E4446A-13

**S E R V I C E N O T E**

E4446A - PSA Series Spectrum Analyzer

**Internal Alignment Failures for PSA Series Spectrum Analyzers Manufactured Between January 2004 and February 2006 Caused by Low Power Output from A9A1 DRO on A9 Second LO Assembly**

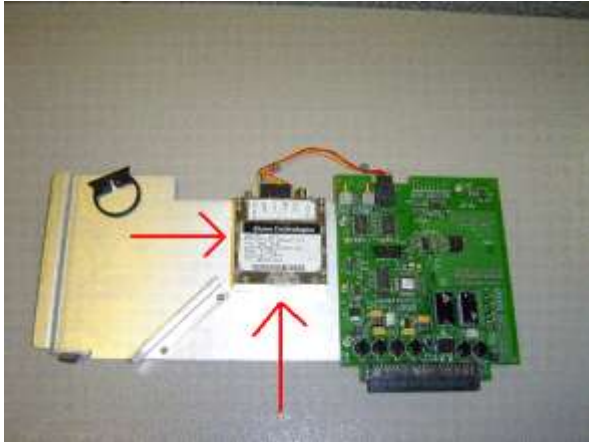
Verify the alignment failure by looking at the error queue for the error message “-340, Calibration failed, Align\_2<sup>ND</sup>\_LO\_PWR”. Press [System] <Show Errors> <Next Page>. Typically, when the Second LO power is too low, it will be the first failure listed in the alignment queue, which will be at the bottom the Second page of alignment errors (as shown below):
